RESOLUTION NO. 2025-067

A RESOLUTION OF THE BOARD OF COUNTY COMMISSIONERS OF COLLIER COUNTY, FLORIDA, AS THE GOVERNING BODY OF COLLIER COUNTY, FLORIDA AND EX-OFFICIO GOVERNING BOARD OF THE COLLIER COUNTY WATER-SEWER DISTRICT, APPROVING AMENDMENTS TO THE COLLIER COUNTY WATER-SEWER DISTRICT'S UTILITIES STANDARDS MANUAL, WHICH IS AN INTEGRAL PART OF COLLIER COUNTY ORDINANCE NO. 2004-31, AS AMENDED, KNOWN AS THE COLLIER COUNTY UTILITIES STANDARDS AND PROCEDURES ORDINANCE, WHICH IS CODIFIED IN CHAPTER 134, ARTICLE III OF THE CODE OF LAWS AND ORDINANCES; AND PROVIDING FOR AN EFFECTIVE DATE.

The amendment of the Collier County Water-Sewer District Utilities Standards Manual as provided in attached Exhibit "A" is hereby approved and shall immediately take effect.

INTRODUCTION

COMMUNITY PUMP STATION WITH DIESEL PUMP DETAIL - PLAN

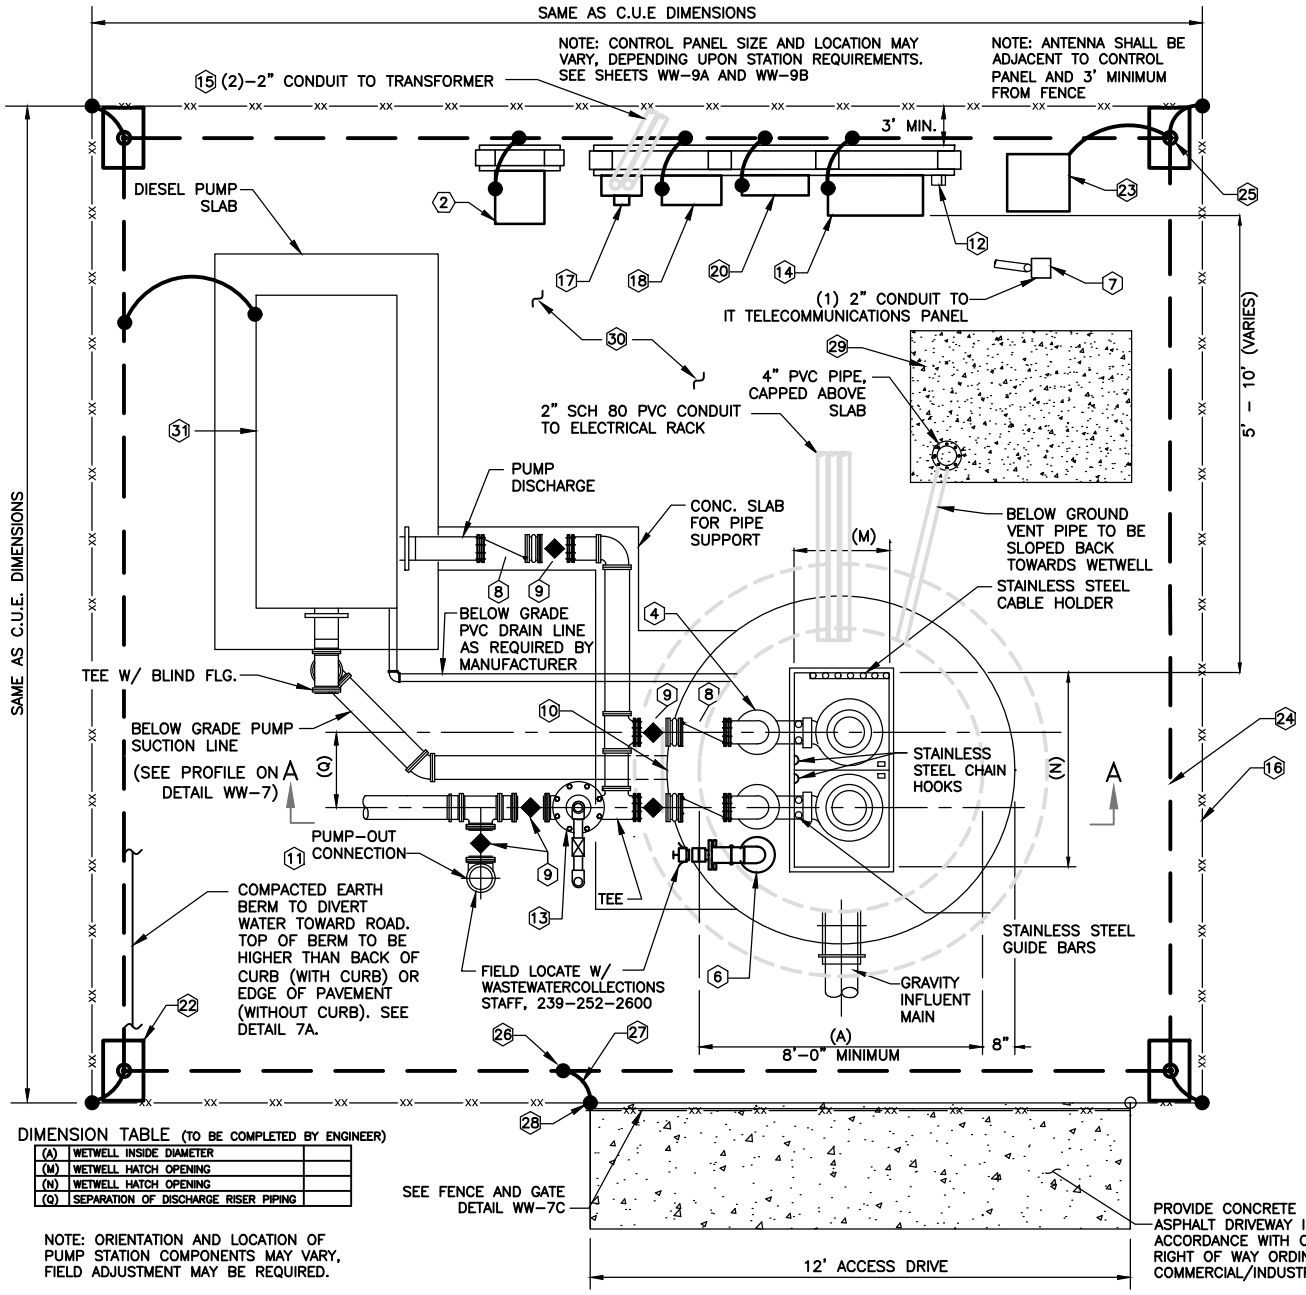
Item	Sub-Section I Detail		Revision Summary	Fiscal Impact of change to Developer (Approx.)
72	WW-8B	Community Pump Station with Diesel Pump Detail - Plan	Note added next to Dimension Table, '(To be completed by EOR)'.	None
73	WW-8B	Community Pump Station with Diesel Pump Detail - Plan	Note added next to section A-A, referencing plan view on detail WW-7.	None
74	WW-9	Pump Station Control Panel Detail	Note # 3 was modified by adding the sentence "Single door panels to open away from wetwell".	None
75	WW-9	Pump Station Control Panel Detail	Added callouts to details: 'Square D Powerblocks to be installed in j-box' & 'Plastic Unistrut endcap callout'	$50/pump station for Square D Powerblocks
76	WW-9	Pump Station Control Panel Detail	Note # 9 was added: "Side panel penetrations are acceptable with the use of Myers Hubs".	$250.00/Hub (Only used when necessary)
77	WW-9	Pump Station Control Panel Detail	Note # 10 was added: "Phase monitor to be installed parallel with FPL meter (on FPL side)".	$100-$350/Monitor (Prices vary with voltages)
